**SUNDRY NOTICES AND REPORTS ON WELLS**  
**Do not use this form for proposals to drill or to re-drill an abandoned well. Use Form 3160-3 (APD) for such proposals.**

**NOTICE OF INTENT TO PLUG AND ABANDON**

**CONTINENTAL FEDERAL #1**

**30-025-24110**

**CURRENT SALADO DRAW; DELAWARE WELL**

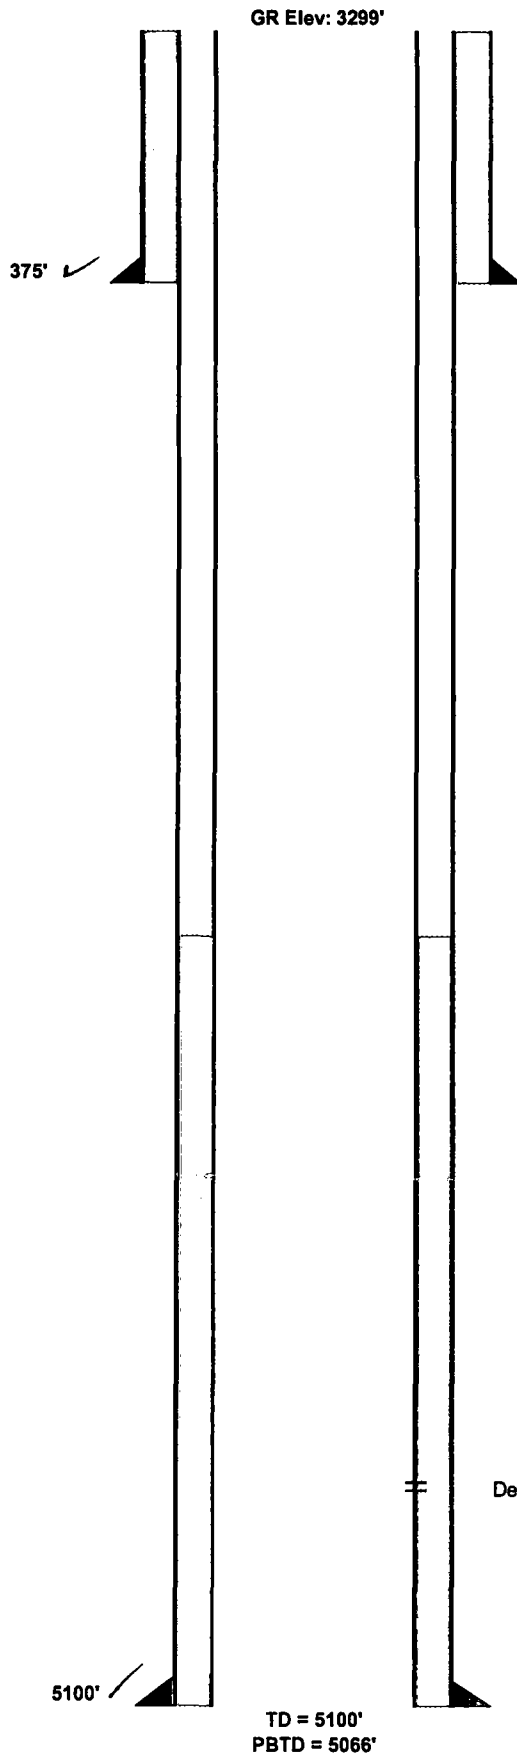
*1" from 60'*

*T/salt 1177-4735*

*Del Line 4960*

*Del sd 4988*

**PLUGGED SALADO DRAW; DELAWARE WELL**

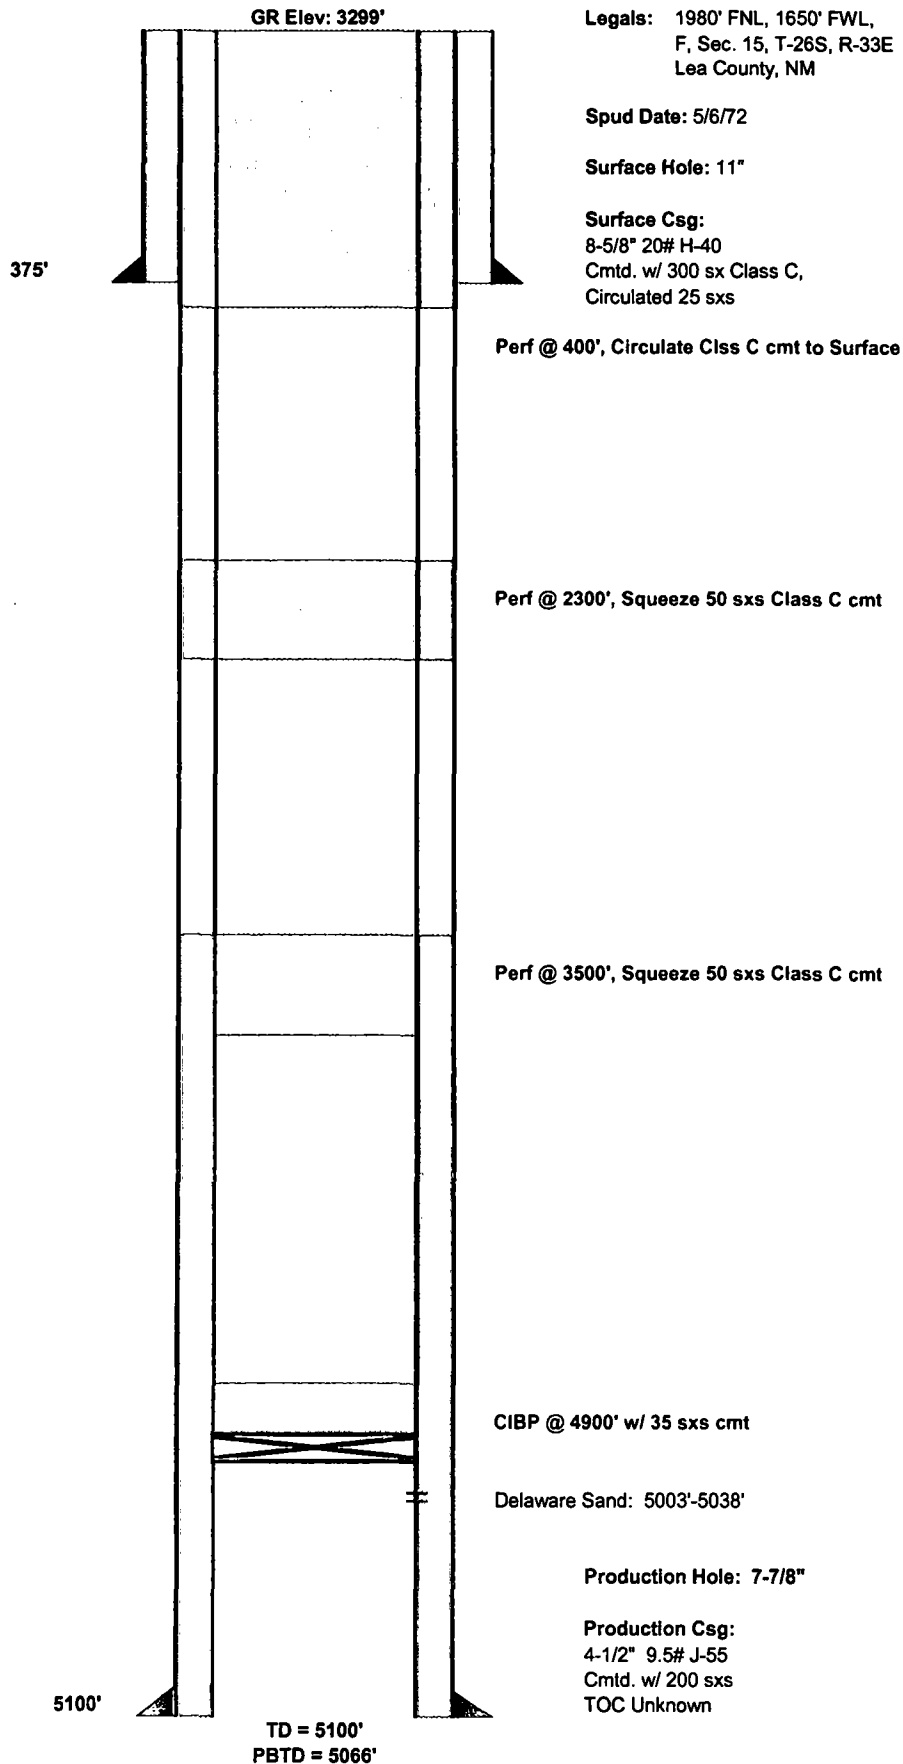
*Below ground level dry hole marker required*
